Access Compliance Report

Public Rights-of-Way

(Pedestrian Signals)

Main Street: N/A Cross Street: CHIQUITA_CANYON_DR Location: SW

ADA ID: SGRK211124133003 Signal Type: One Push Button-Non APS Overall Compliance: No Severity Scores: BTN 1: 35 BTN 2: N/A No BTN: N/A

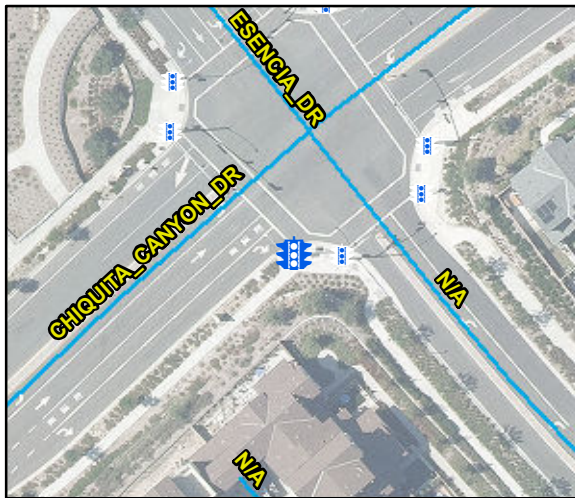
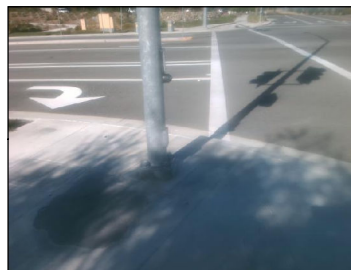
Possible Solutions: Replace Signal Push Button With APS Button. Remove and Replace Clear Space.

OC Std/PROW: R404.2, MUTCD 4e.08
